**UTAH DIVISION OF WILDLIFE RESOURCES
LOA HATCHERY
WASTE STATION CLARIFIER DESIGN - 2004**

**State of Utah
Division of Facilities Construction & Management
DFCM Project No: 04218520**

**ADDENDUM #1
March 1, 2005**

E2

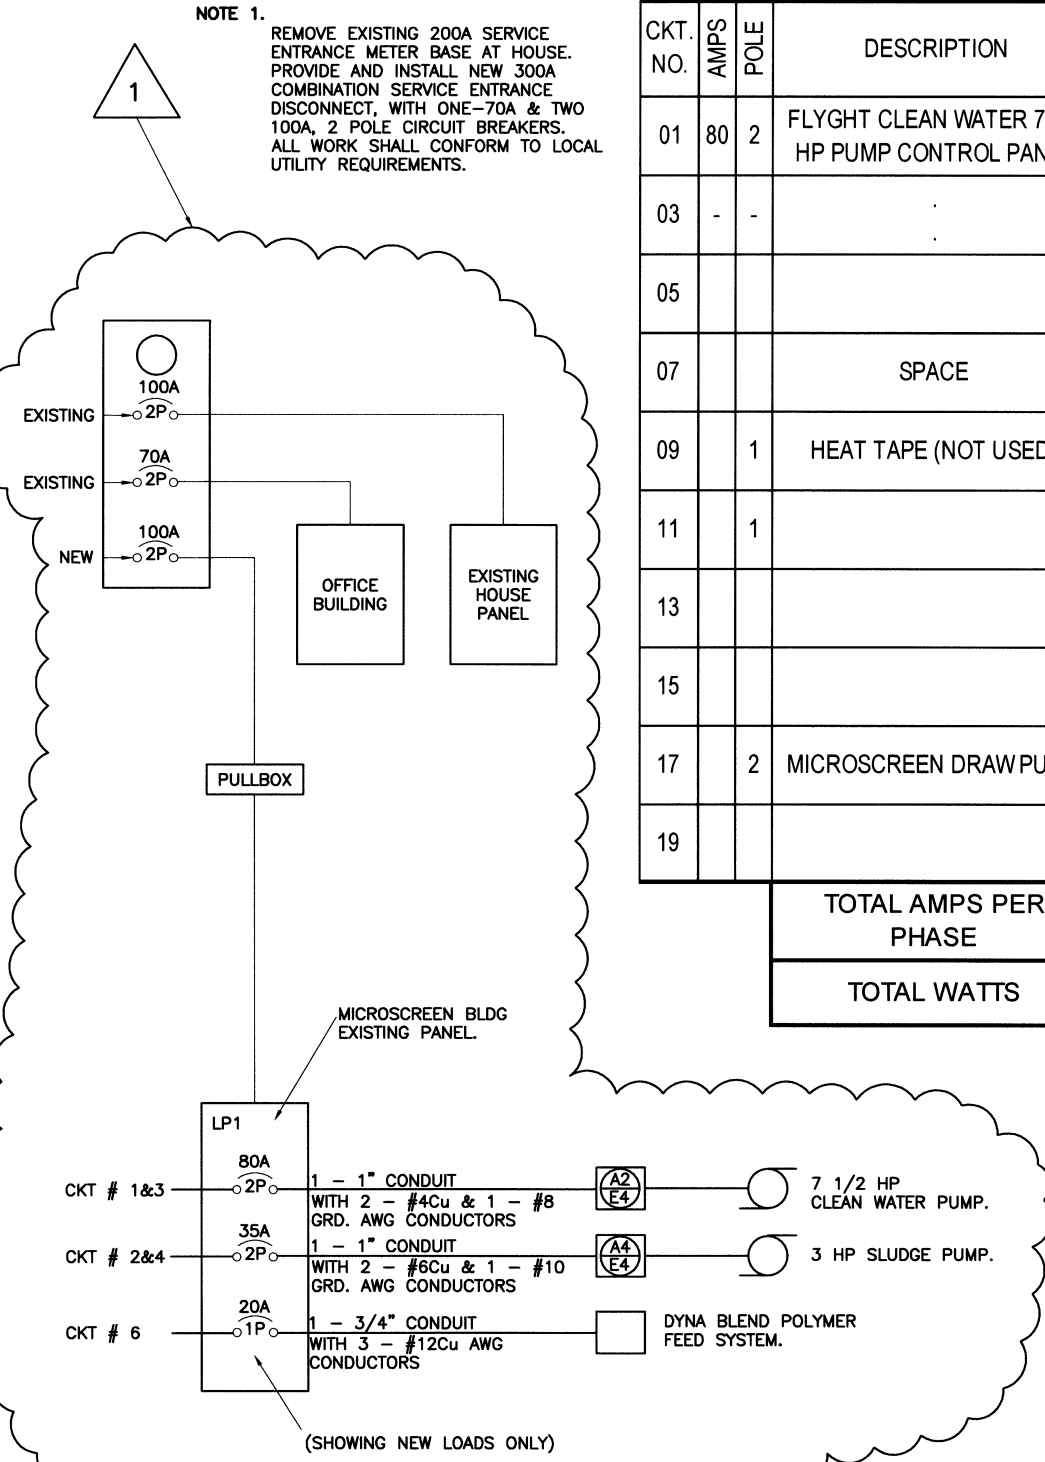
A change has been made to Drawing E2. This drawing has been attached to this addendum. The changes include.

- Removing the 200 amp service entrance and replacing it with a 300 amp service.
- Upgrade the existing 60 amp breaker to a 100 amp breaker in the micro screen building.
- The micro screen building breaker box has been reconfigured in an effort to balance loads.
